SERVICE MANUAL

Service Manual

'95 Model Changes

OUTLINE OF THE '95 MODEL CHANGE

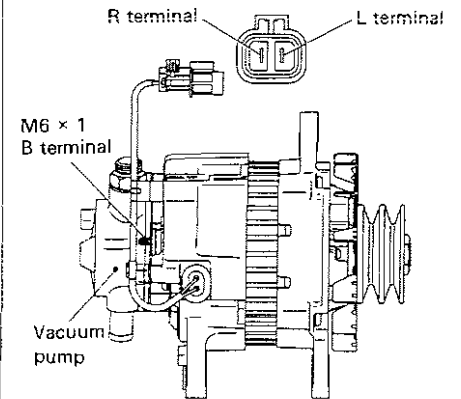
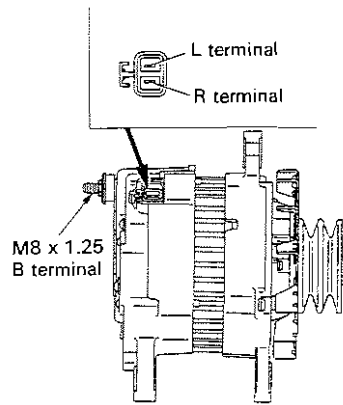
(17) Connection between the exhaust pipe and the front pipe is changed to improve the sealing effect.

Service procedures are unchanged.

(18) Alternator is changed as follows:

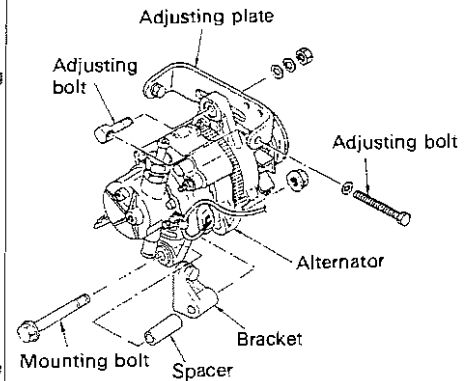
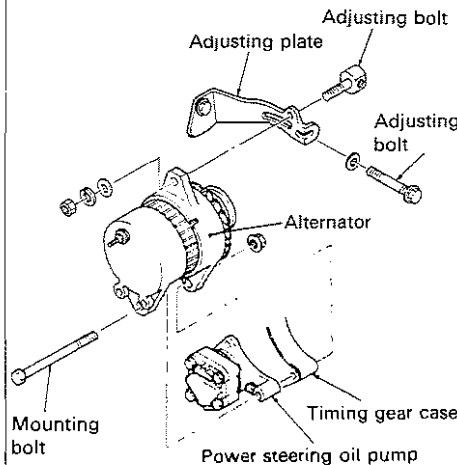
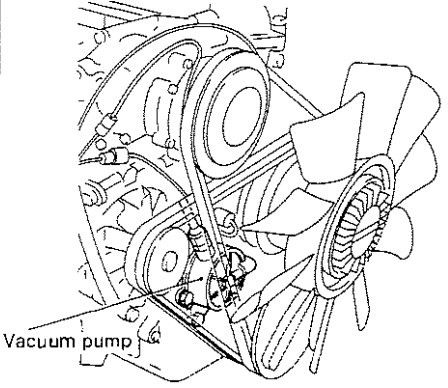
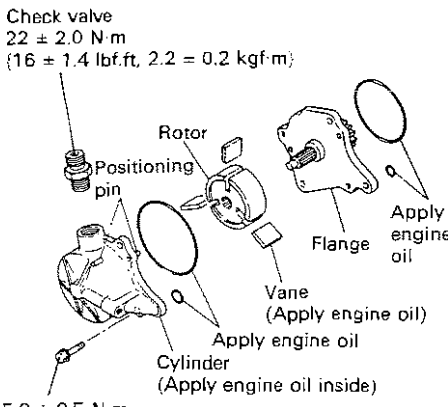
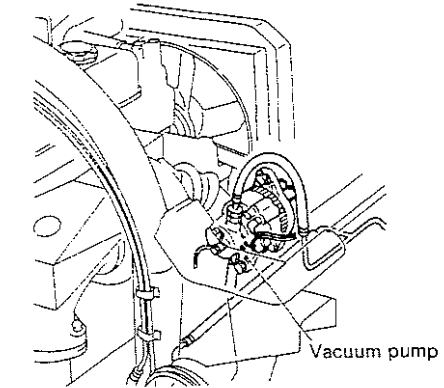
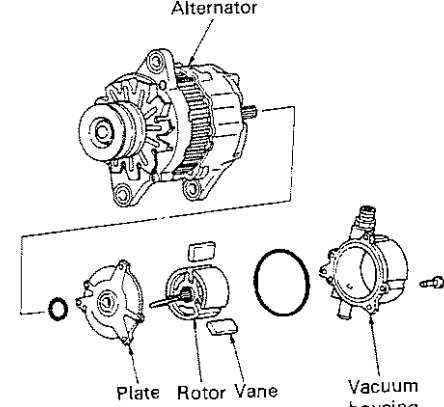
- Harnesses of L, R connectors are eliminated.
- Diameter of B terminal screw is enlarged.
- Vacuum pump is eliminated (Vacuum pump is now driven by the gear so that it is assembled on the engine main body).

- Resistance value of field coil is changed.

Type	A4TU0088	A4T25788
Field coil resistance	2.7 to 3.3 Ω	3 Ω

- Adjusting plate is changed.
- Spacer on the alternator retaining fulcrum is eliminated and is now secured together with the power steering oil pump (has an integrated spacer).

Service procedures are unchanged.

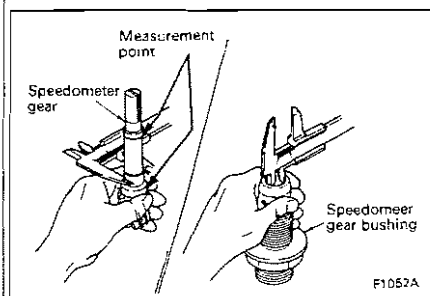
(21) Shift fork set bolt and jaw set bolt are changed. As a result, the tightening torque is also changed. Further, a special tool Hexagon Bit is newly specified.

When changing the set bolts on the currently used transmission, these new bolts can be used. In such occasion, it is necessary to rework the threaded section of the shift fork or the jaw using a tapping tool in order to avoid the effect of calked section. Where the same set bolts as those specified at this time have already been in use, replace them with new bolts when they are removed at disassembly. In such occasion, make sure to remove completely old locking material left over on the threaded section of the shift fork or jaw.

Tightening torque	29 to 36 N·m {22 to 28 lbf.ft, 3.0 to 3.7 kgf·m}	29 N·m {22 lbf.ft, 3.0 kgf·m}
Locking	Locking material is applied to the set bolt.	Calked at more than 3 places on the thread (* marked in above sketch) with a punch.
Special tool	Hexagon bit MH063060 10 mm {0.39 in.} 6.35 mm {0.25 in.} 5 mm {0.20 in.}	None
Reuse	Prohibited (Replace when disassembled)	Allowable

Service procedures are unchanged excepting the above.

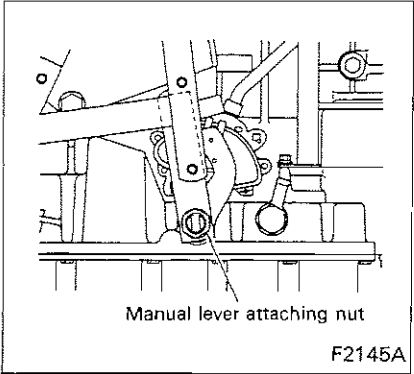
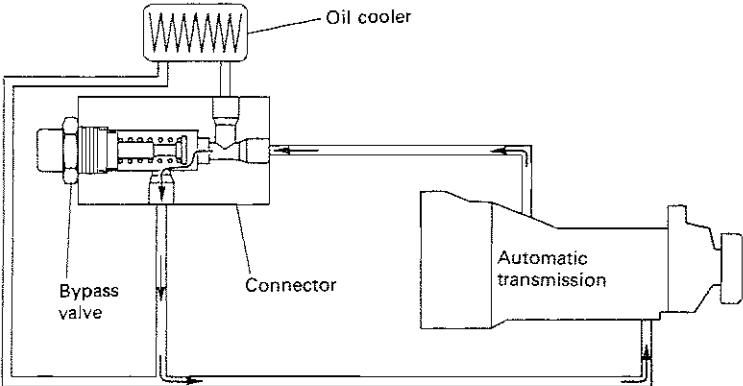
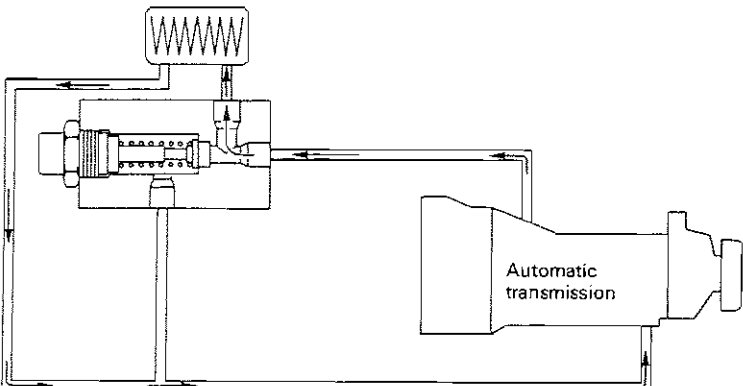
(22) Speed meter gear is changed to make the oil clearance on the speed meter gear bearing more appropriate.

Inspection
Clearance between the speedometer gear shaft and bushing.

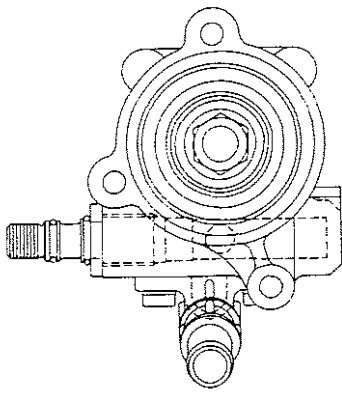
Measure the outer diameter of the speedometer gear shaft and bushing, and then calculate the clearance.

Basic diameter	12 mm {0.47 in.}	12 mm {0.47 in.}
Nominal value	0.04 to 0.09 mm {0.0016 to 0.0035 in.}	0.02 to 0.07 mm {0.00079 to 0.0028 in.}
Limit	0.15 mm {0.0059 in.}	0.15 mm {0.0059 in.}

Service procedures are unchanged.
